Author responses to executive editor comments in red

Executive editor decision: Reconsider after major revisions (further review by editor and referees)

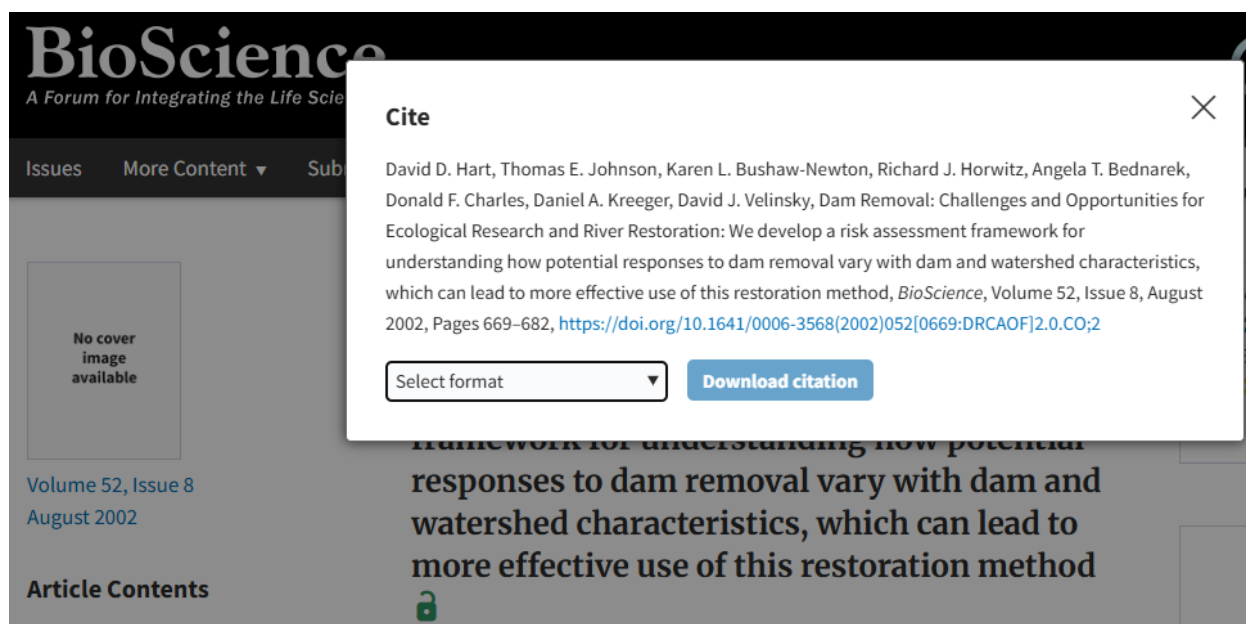
Technical corrections: Check the reference list entry for Hart, DD (title seems to include part of abstract and DOI does not work). The 2 Blakey DOIs do not seem to work either. I would recommend checking over the whole list for errors and links that don't work. Line 387 doesn't end in a period.

We checked all 3 of these DOIs and they do work. We have hyperlinked them in the text, which we hope will resolve the issue. Apologies for the Hart reference, the citation exporter indeed includes more of the title than the article itself (see screenshot for reference) and we have made this correction in the manuscript. We have added a period to line 387. Apologies that this was missed in the conversion from a track-changes version to an accept-all version of the manuscript for the resubmission. We also thoroughly checked each citation and made edits in the introduction and background as needed after a very thorough proofread (as recommended in the following editor suggestion).
